2ND INSTALLMENT

THE VILLAGE ON THE PARKWAY

PAVING & GRADING
IMPROVEMENTS
WATER, SANITARY SEWER & STORM SEWER
IMPROVEMENTS

ALBERT H. HALFF ASSOCIATES, INC.-ENGINEERS
DALLAS, TEXAS
FEB. - 1979
A.V.O. 6143Z

HORIZONTAL LAYOUT & PAVING PLAN						
VILLAGE ON THE PARKWAY						
VILLAGE PARKWAY VENTURE						
Albert H. Holt Associates, Inc. - Engineers						
CITY OF ADDISON, TEXAS						
DESIGN	DRAWN	DATE	SCALE	NOTES	FILE	No.
A. H. H. ASSOC.	A. H. H.	JUNE 78	1/2\"/>

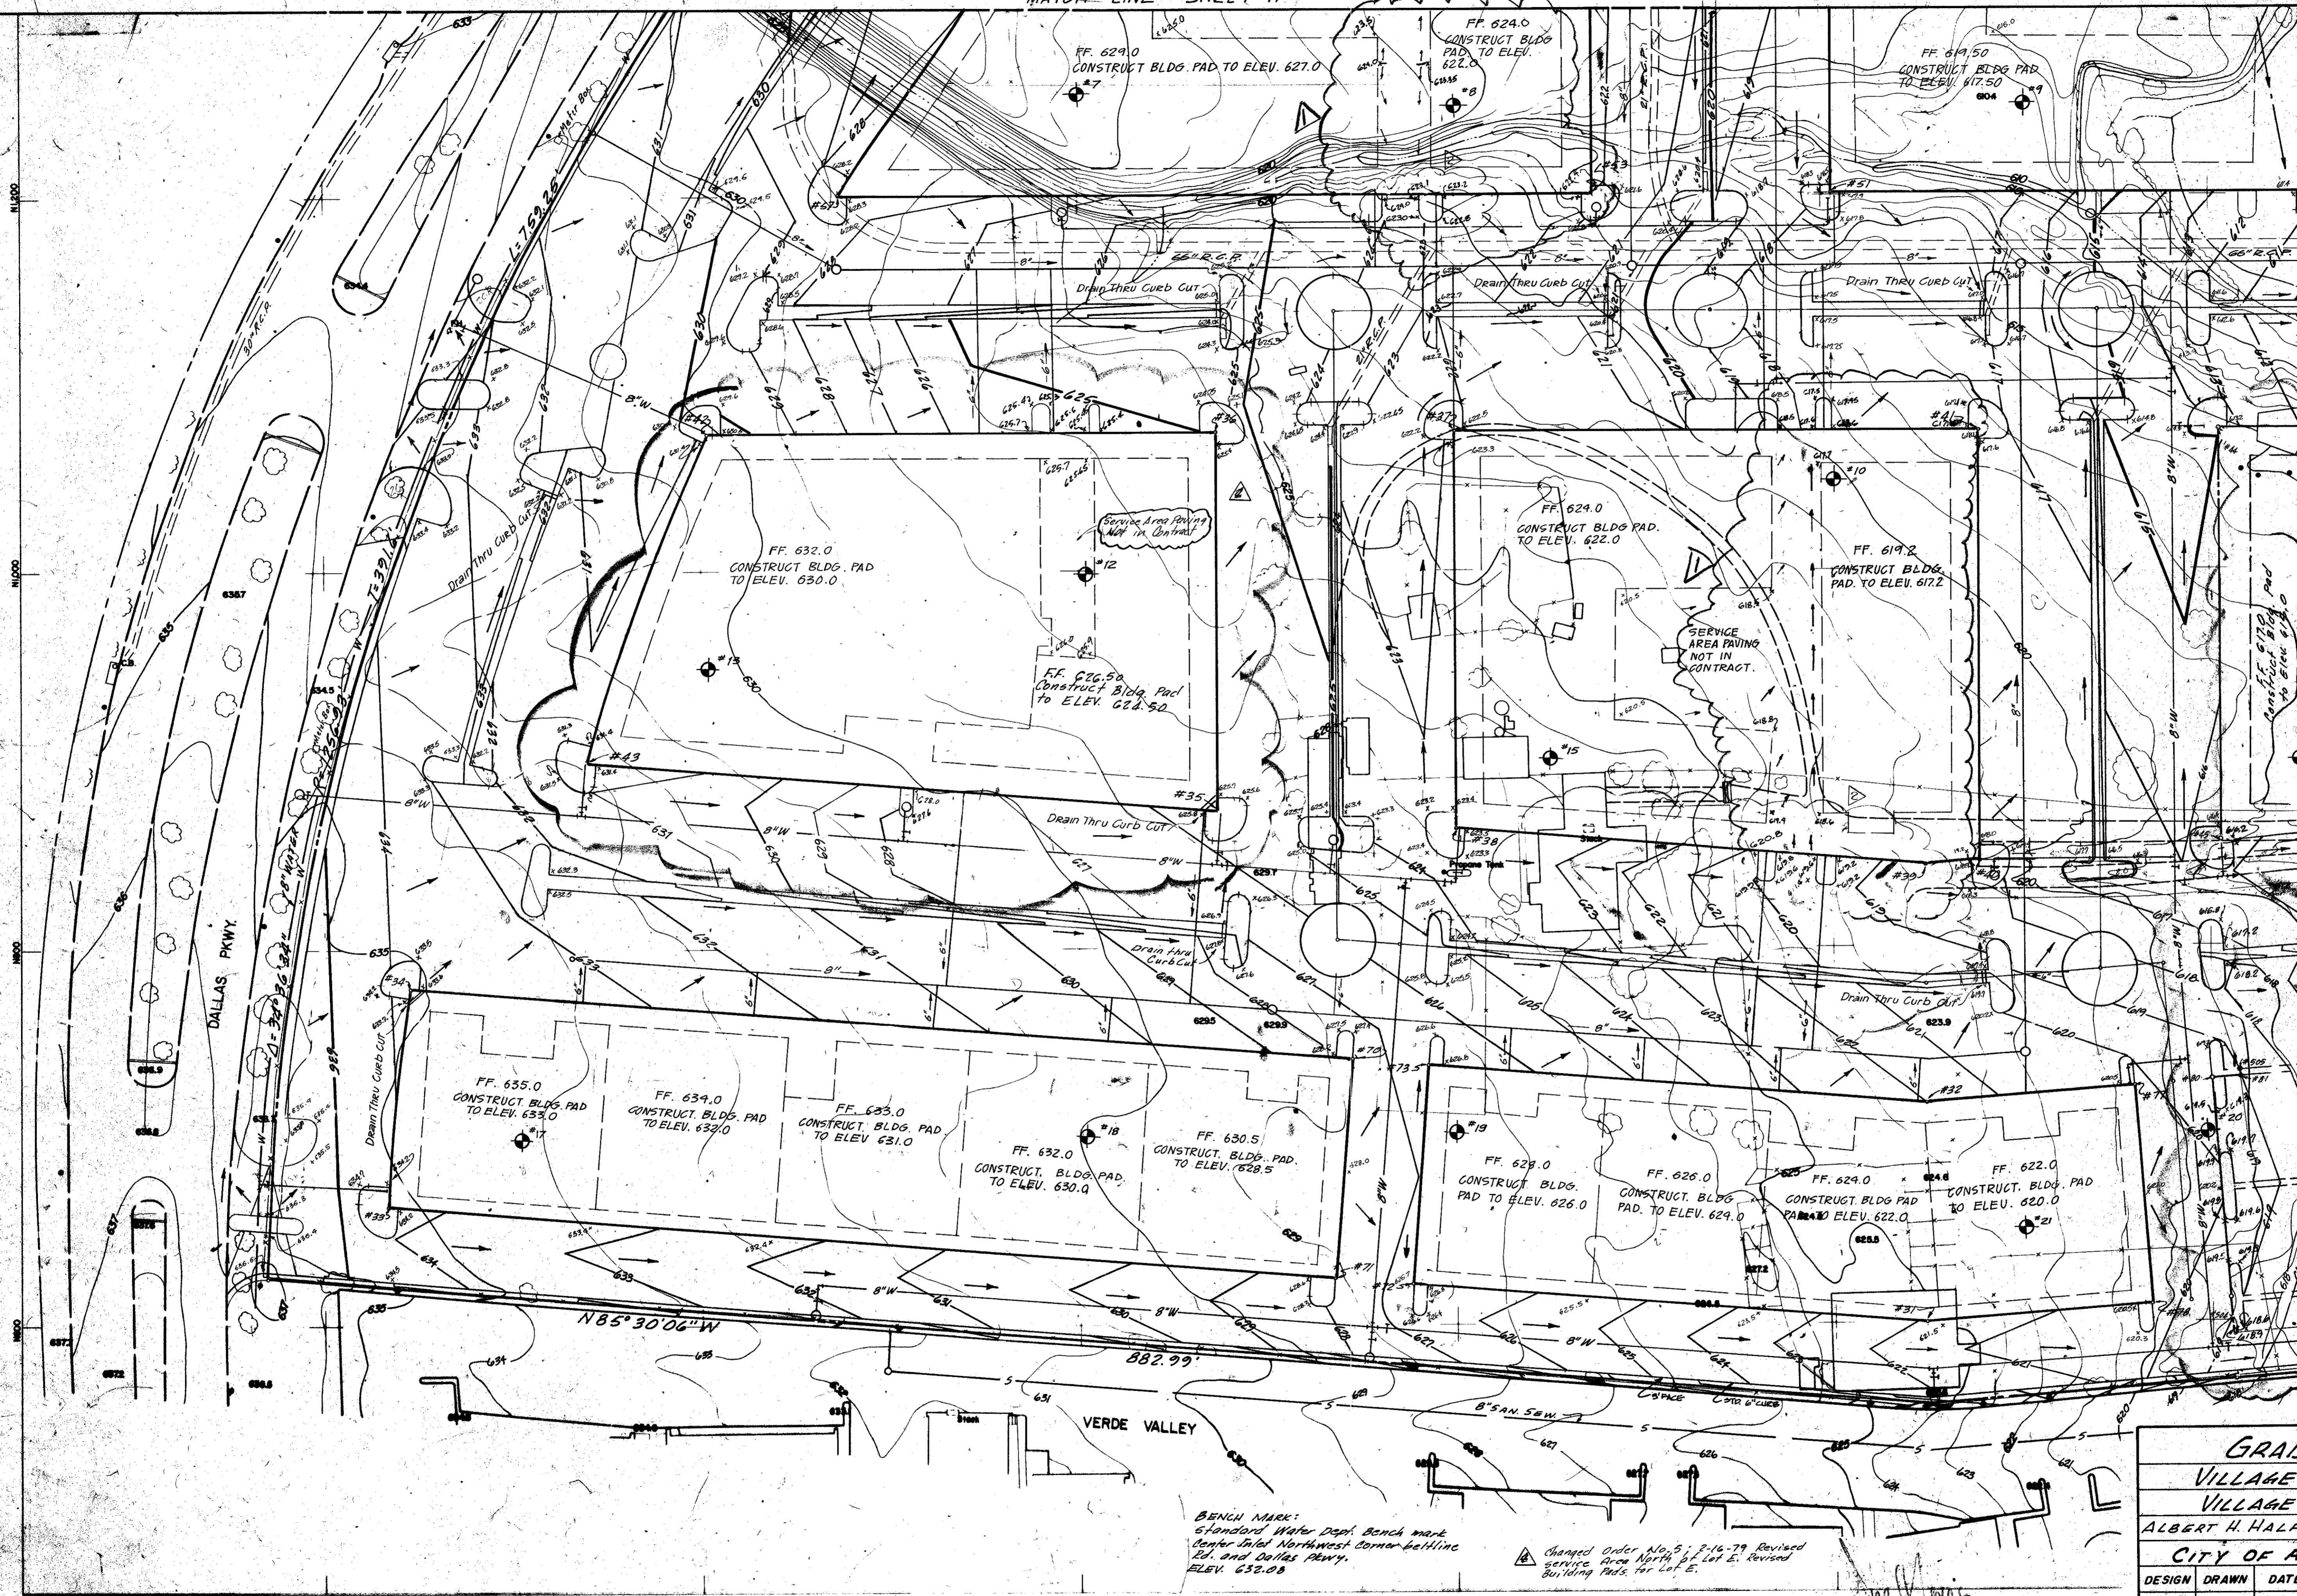
3/28/79 Added Horizontal Layout & Paving Plan for Second Installation.
7/26/78 Added TURN LANE CURSE DATA

GRADING PLAN
VILLAGE ON THE PARKWAY
VILLAGE PARKWAY VENTURE
 ALBERT H. HALFF ASSOCIATES, INC. - ENGINEERS
 CITY OF ADDISON, TEXAS

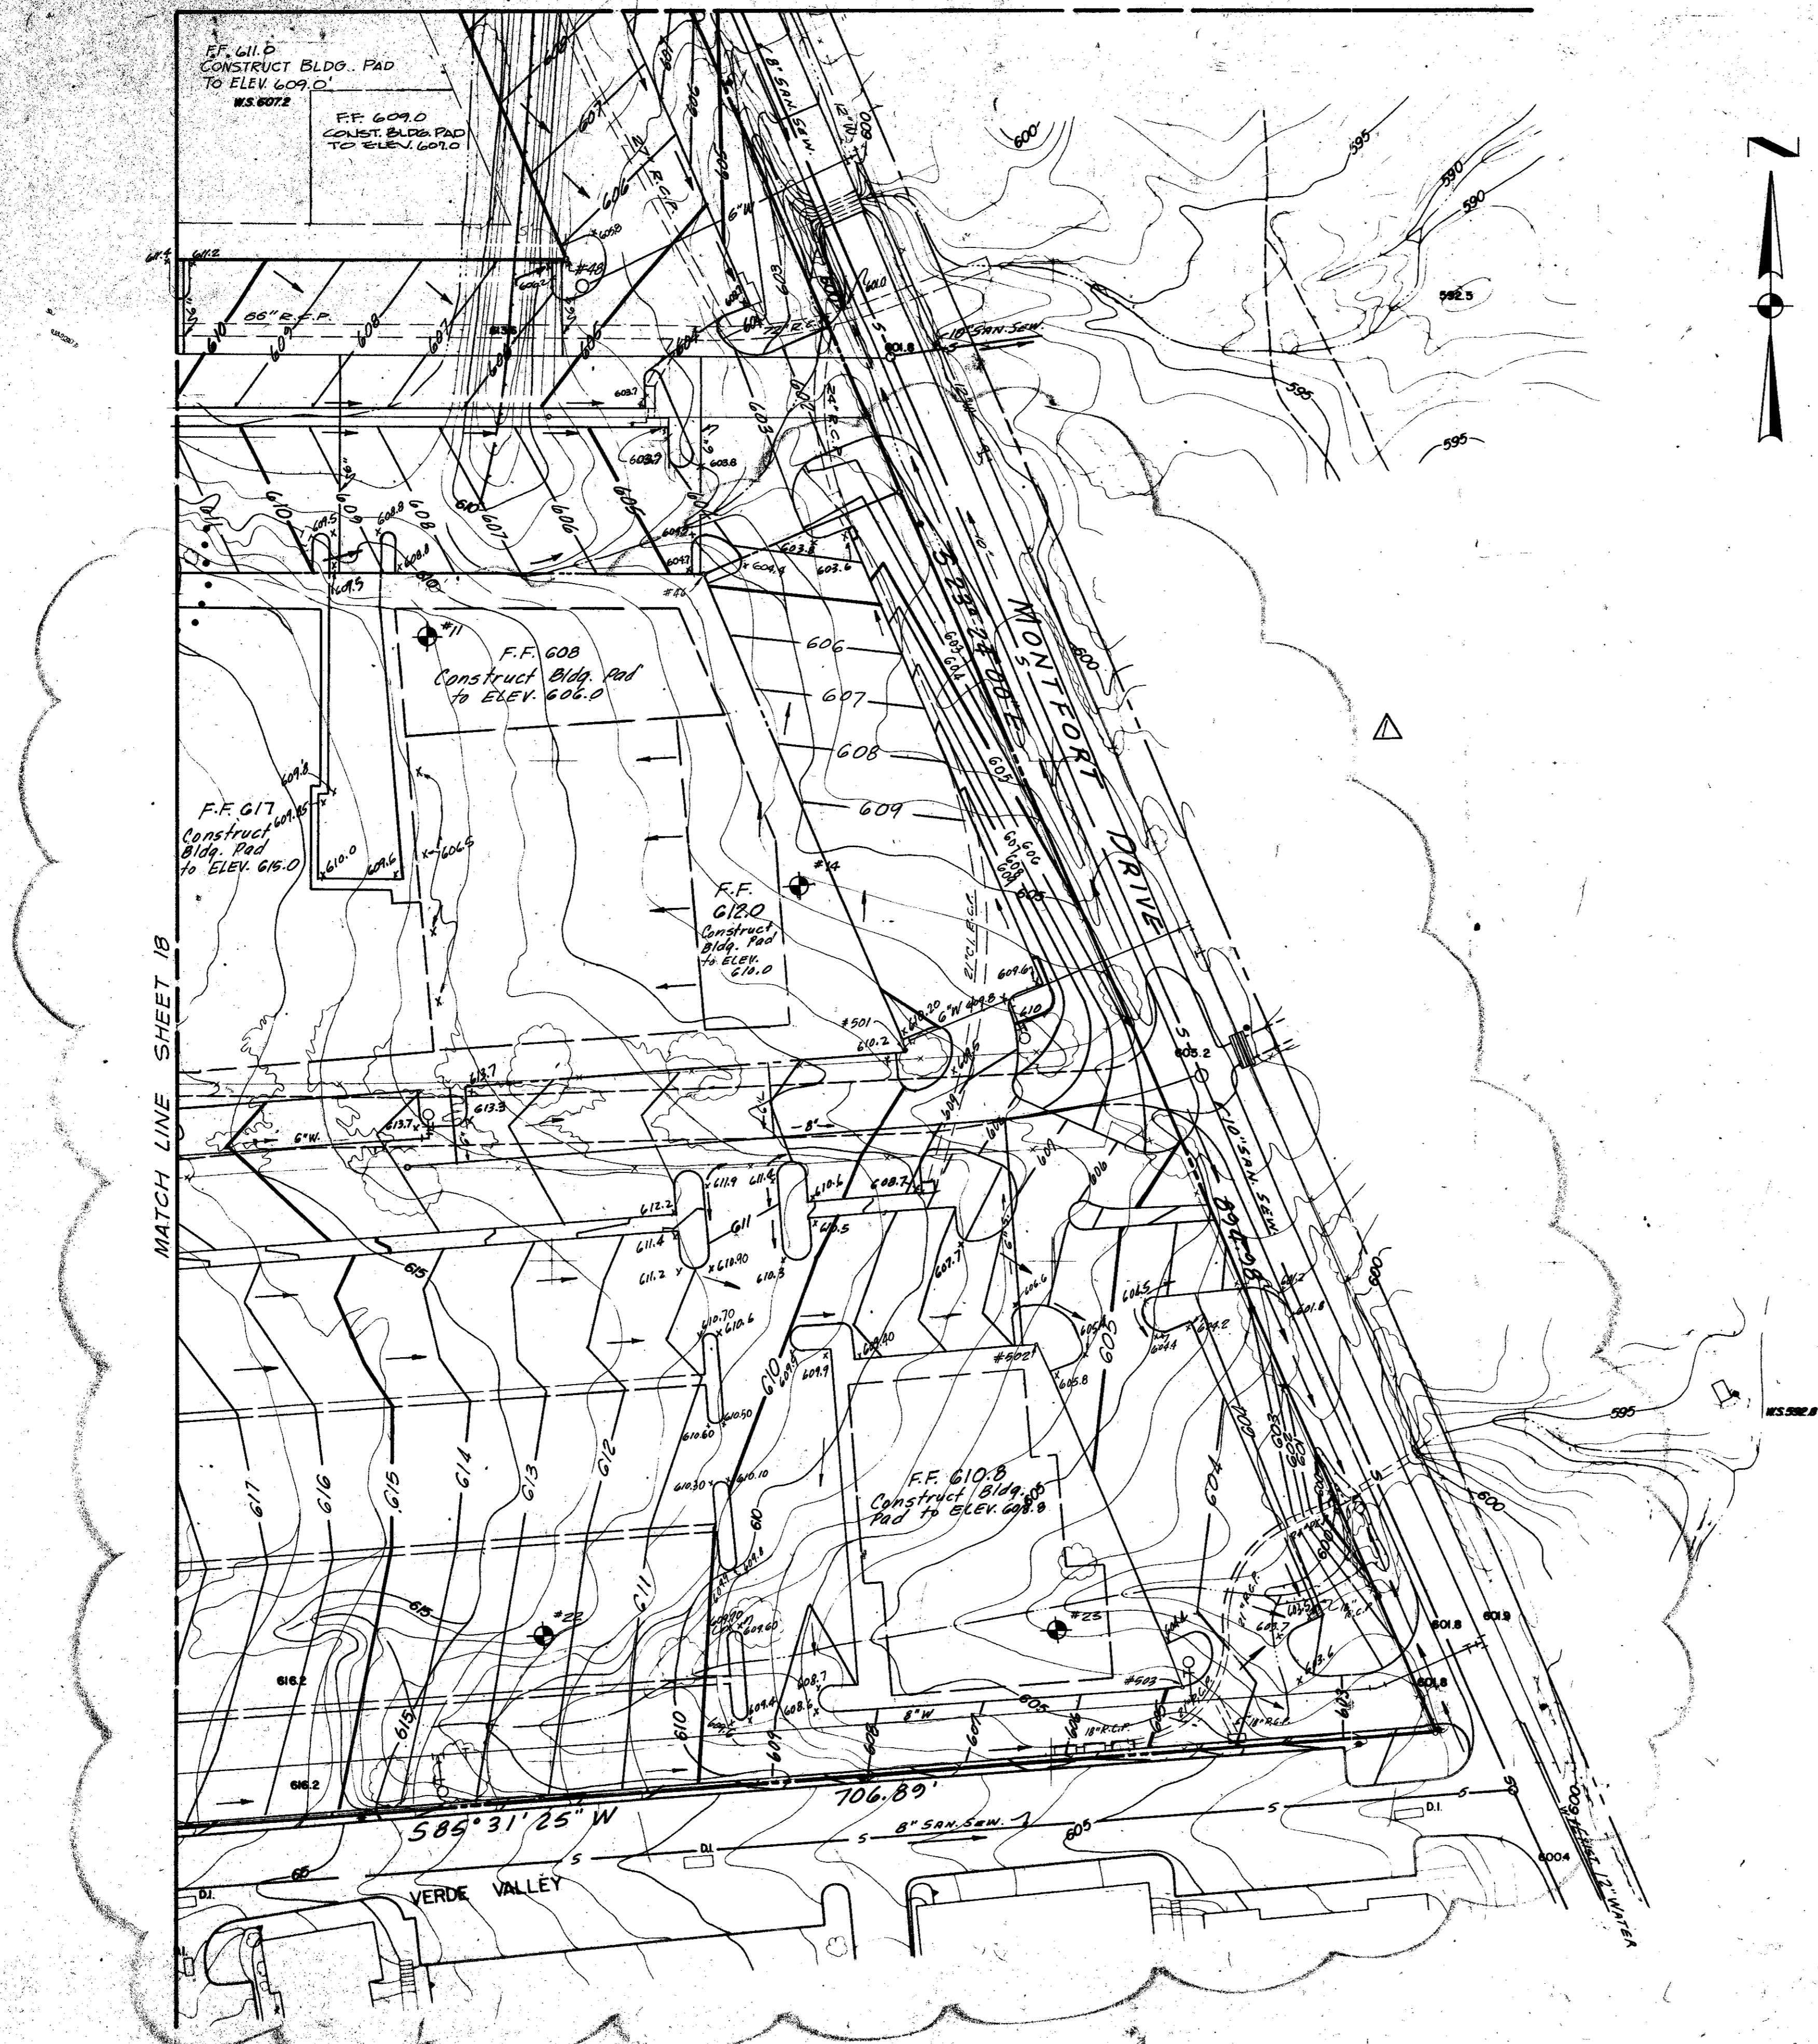
GRADING PLAN FOR 2nd INSTALLMENT
 INDICATES SOIL BORING
 REVISOR SERVICE DRIVE LOCATION, SOUTH SIDE LOT C.
 REVISOR SERVICE AREA GRADES AND LOCATION, SOUTH SIDE LOT F 10/30/78
 REVISOR BLDG. AND SERVICE AREA GRADES 9/7/78

Changed Order No. 5; 2-16-79 Revised
 service area North of Lot E. Revised
 Building Pads for Lot E.

GRADING PLAN
VILLAGE ON THE PARKWAY
VILLAGE PARKWAY VENTURE
 ALBERT H. HALFF ASSOCIATES, INC. - ENGINEERS

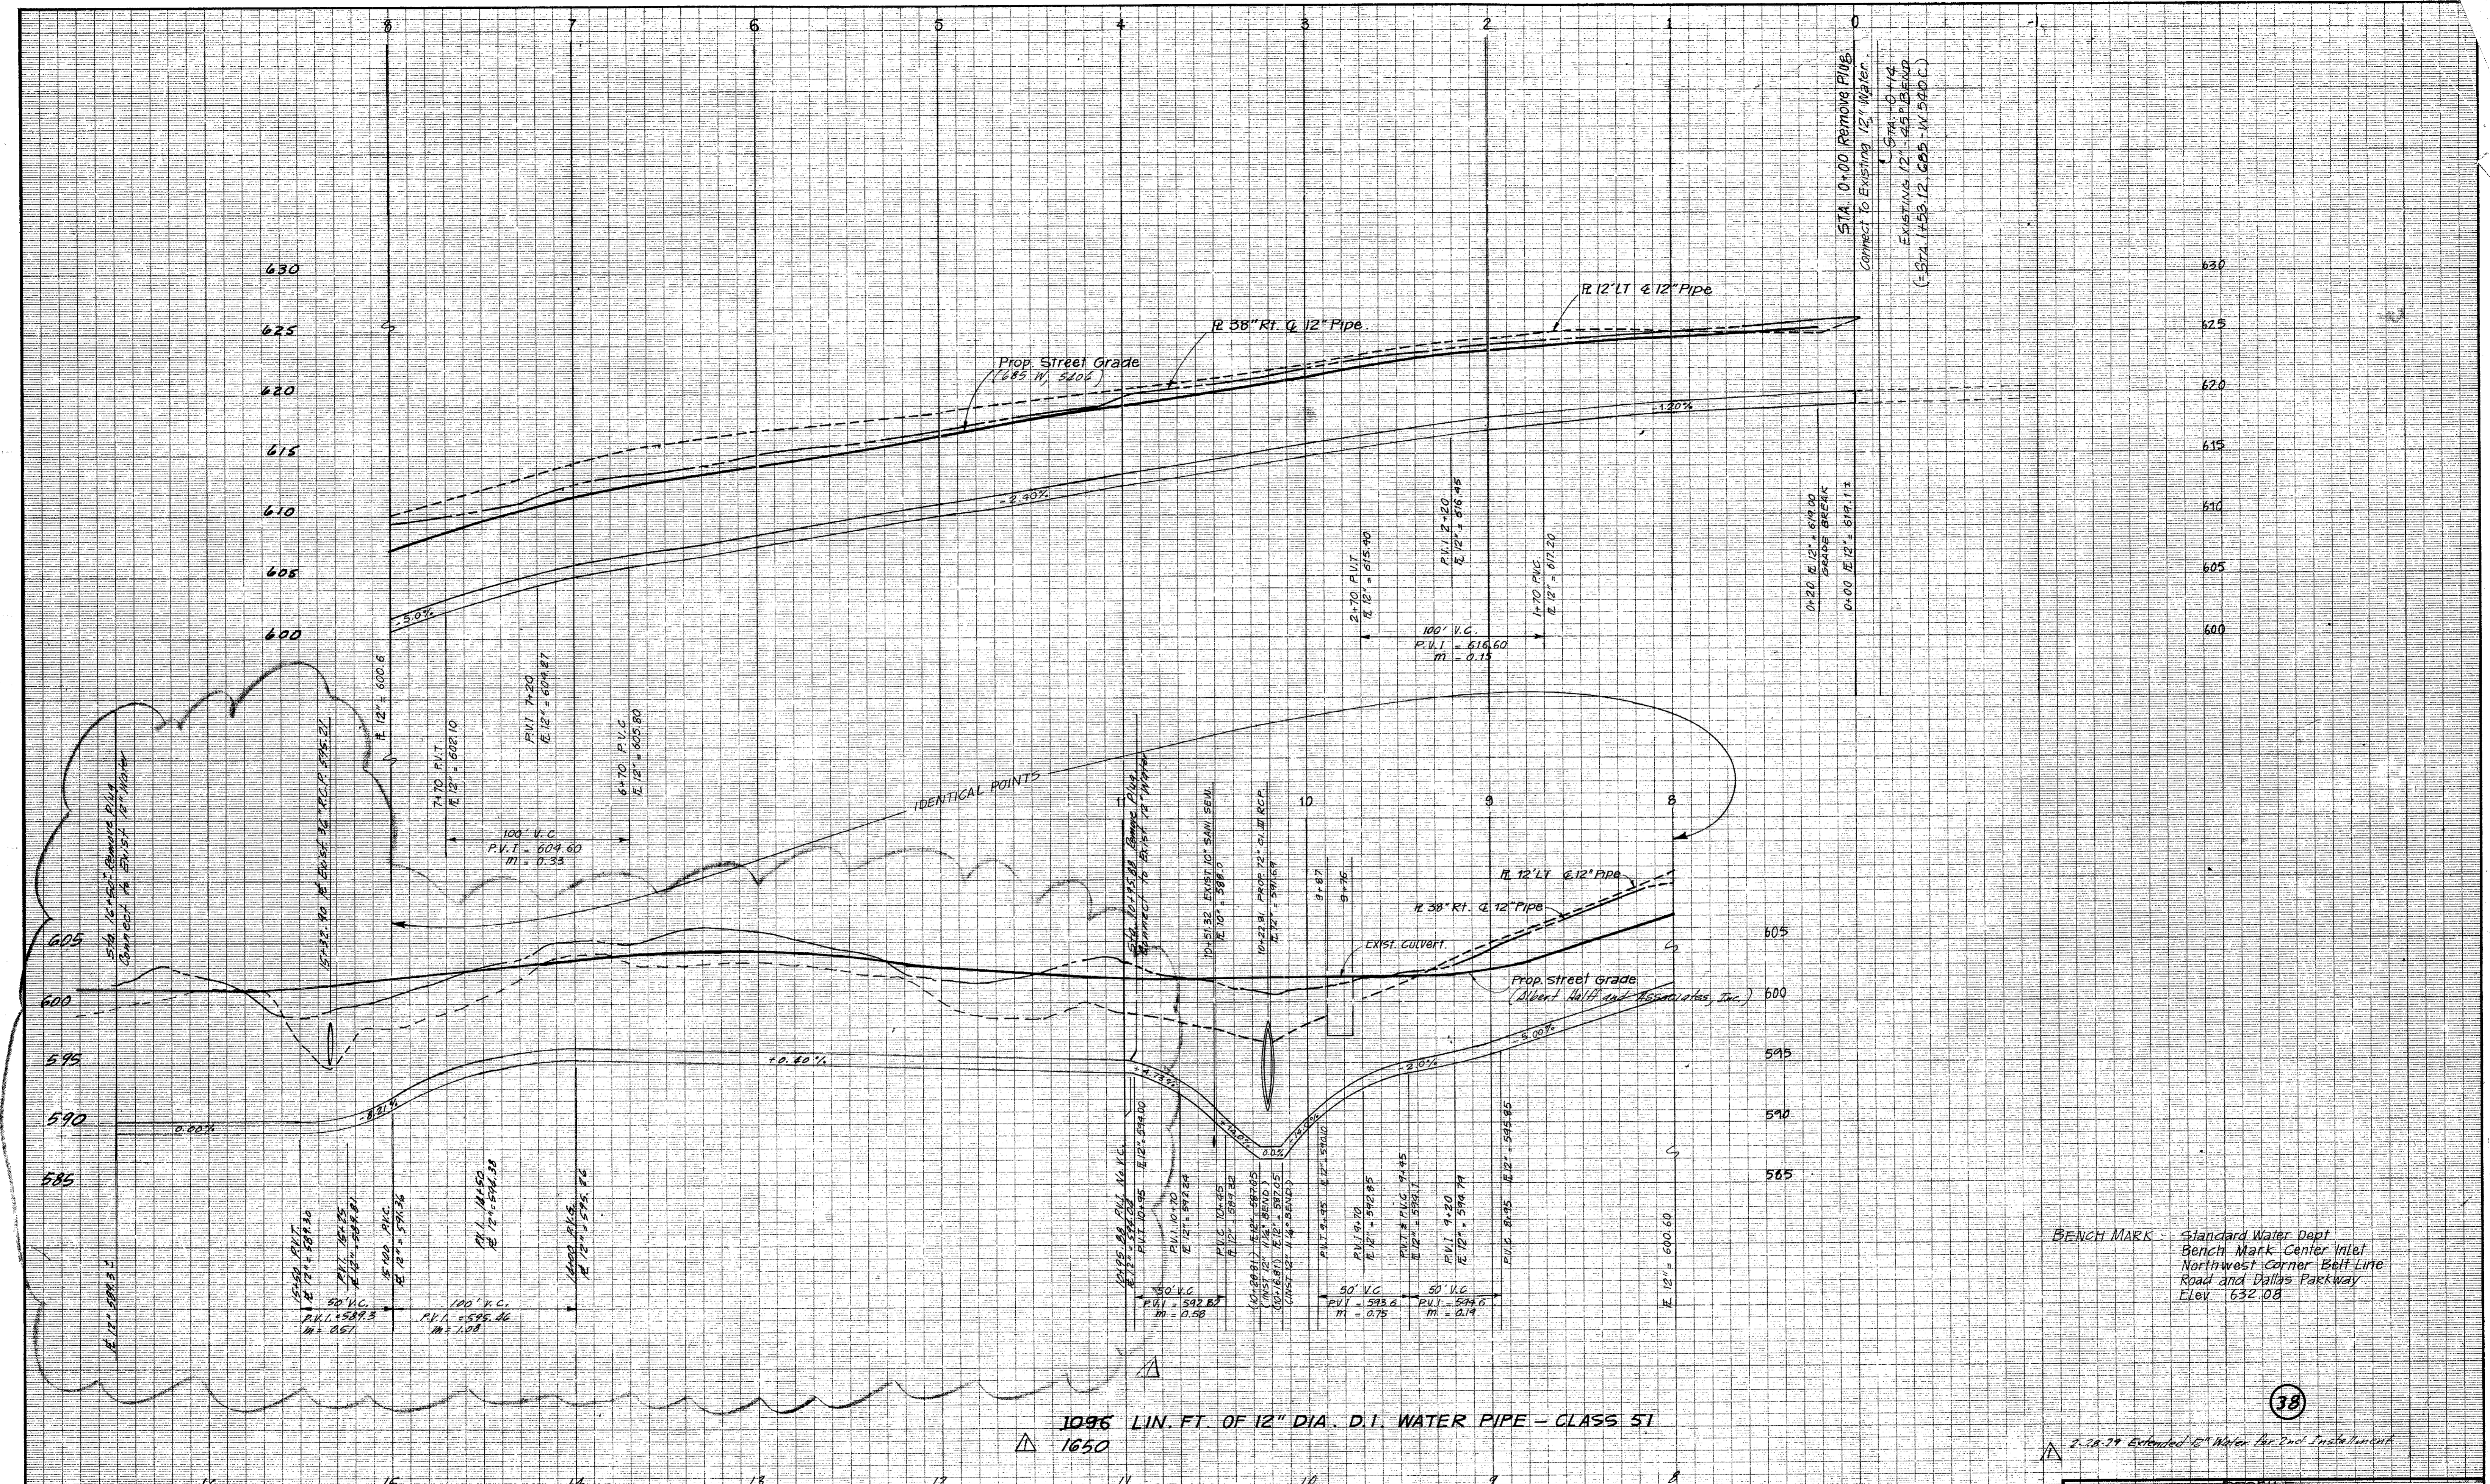
- LEADING PLAN FOR 2ND INSTALLMENT
- ◆ INDICATES SOIL BORING
 - ⊙ REVISED SERVICE DRIVE LOCATION, SOUTH SIDE LOT C.
 - ⊙ REVISED SERVICE AREA GRADES AND LOCATION, SOUTH SIDE LOT F (10/30/78)
 - ⊙ REVISED BLDG. AND SERVICE AREA GRADES 9/7/78

Change Order No. 5; 2-16-79 Revised
 Service Area North of Lot E. Revised
 Building Pads for Lot E.

Change Order No. 6; 3-12-79 Addition of
 Island & Spot Elevations, South side
 Lot C
